Finals Lay-out

FINAL AMPLIFIER 80361

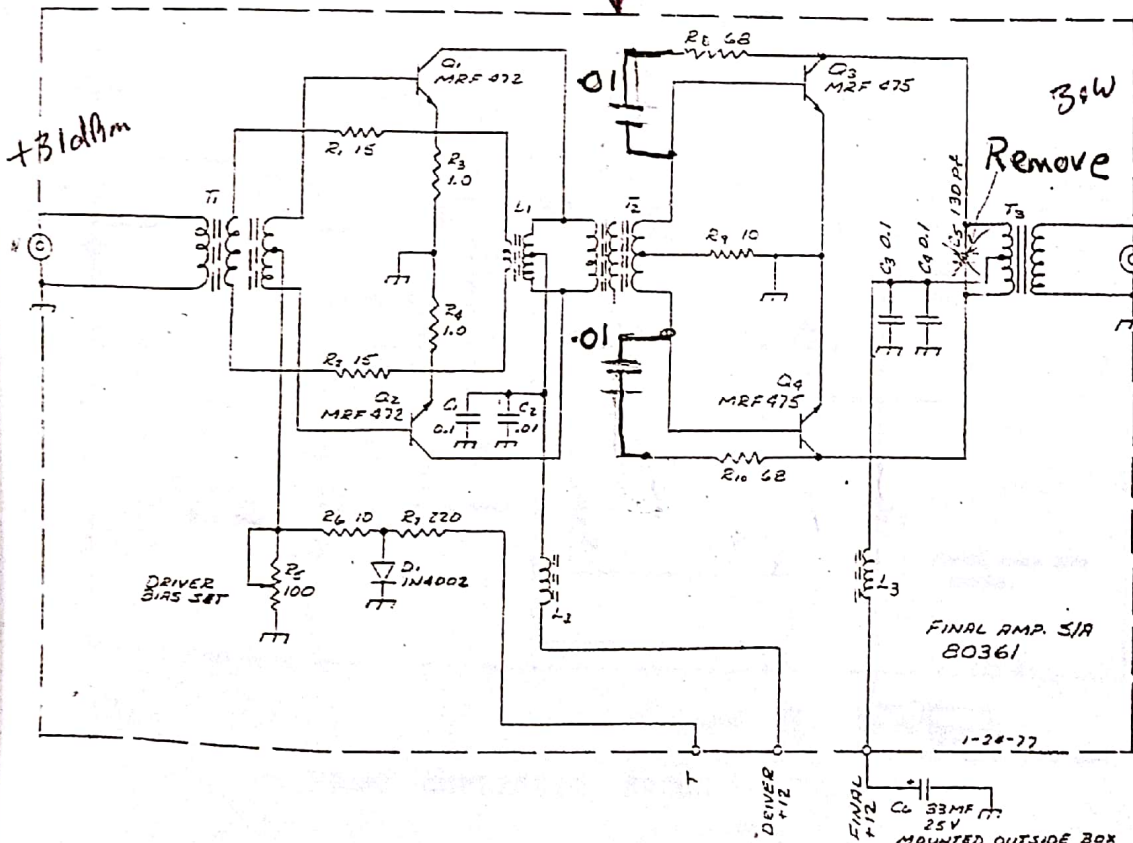
Remove Center Leg Common To Tab

R5  
DRIVER BIAS

MRF 475 sub ZSC1969  
MRF 472 sub ZSC2314

OR, 0.1 μf  
MULTI LAYER

Replace C1-C4 with 23006, .1mf film cap  
 Replace D1 with 28007, 1N4002  
 Replace O1-2 with 25278, ZSC2314  
 Replace Q3-4 with 25223  
 ZSC1969

SET driver BIAS per 3-24
